Peer-Review

Hu, Roland. 2025. "Altitude-Dependent Performance Analysis of Bell, Aerospike and Expansion-Deflection Nozzles for Rotating Detonation Engines." *Journal of High School Science* 9 (4): 394–412. <https://doi.org/10.64336/001c.154674>

Figure 1: Performance of three different RDE nozzle types across a range of ambient pressures. The effects of ambient pressure on (a) the thrust and (b) the percentage of ideal thrust. Thrust was obtained from CFD simulations, while ideal thrust was calculated with isentropic flow equations.

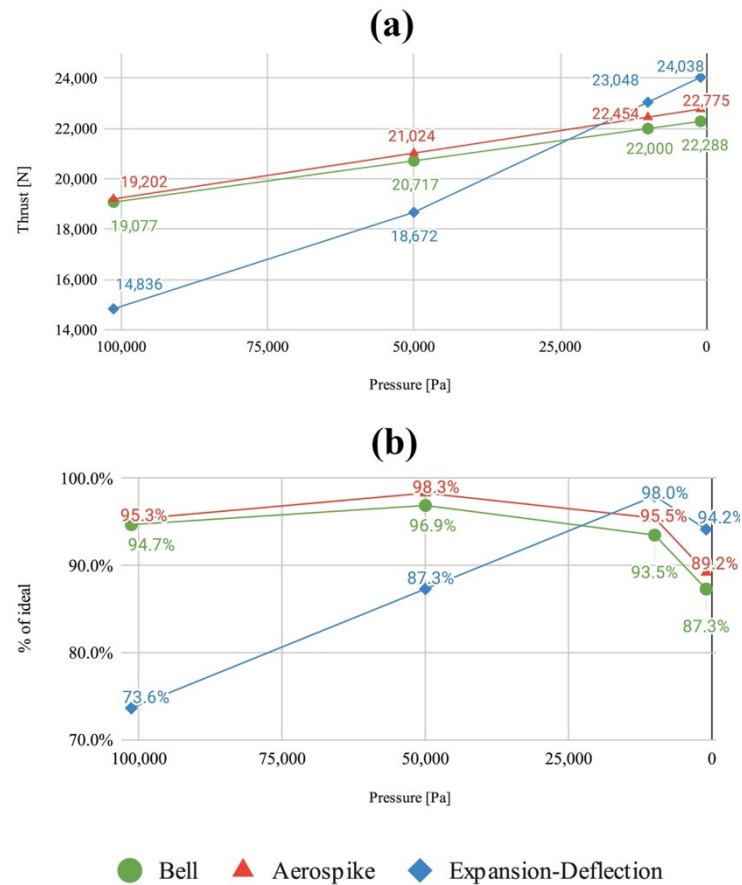
1. Remove the word 'ambient' before the word 'pressure' in X-axis titles from figures.
2. Provide the propellant mass flow rate in the legend of Table 6 (and in other tables where specific impulse is mentioned). even though you have provided it at the start in Table 1.

3. If there are two performance downgrades at 50 and 101 kPa for ED, should there not be two slope transitions for 100 to 50 and then for 50 to 10 kPa? Instead, figure 4 shows no such duality in slopes. Why?

1. **Remove the word 'ambient' before the word 'pressure' in X-axis titles from figures.**
The term "ambient" has been removed from all X-axis titles, now using "Pressure [Pa]" in Figure 4(a) and 4(b).

The performance downgrades for the ED at 101 and 50 kPa are due to the low pressure recirculation zone at 101 kPa and lower-than-ambient exhaust due to premature wake closure at 50 kPa, causing a large negative contribution from pressure. However, total thrust and percent of ideal thrust still increase as pressure decreases because the exit pressure remained similar. As a result, decreasing ambient pressure contributes nearly linearly to both metrics, producing similar slopes between pressure points. A finer pressure sweep may resolve additional differences in slope, particularly near the wake transition. This clarification has been added to the Figure 4 caption.

"The smooth trends reflect interpolation between points; however, a finer pressure sweep may reveal differences in the trends, particularly for the ED nozzle near wake transition."
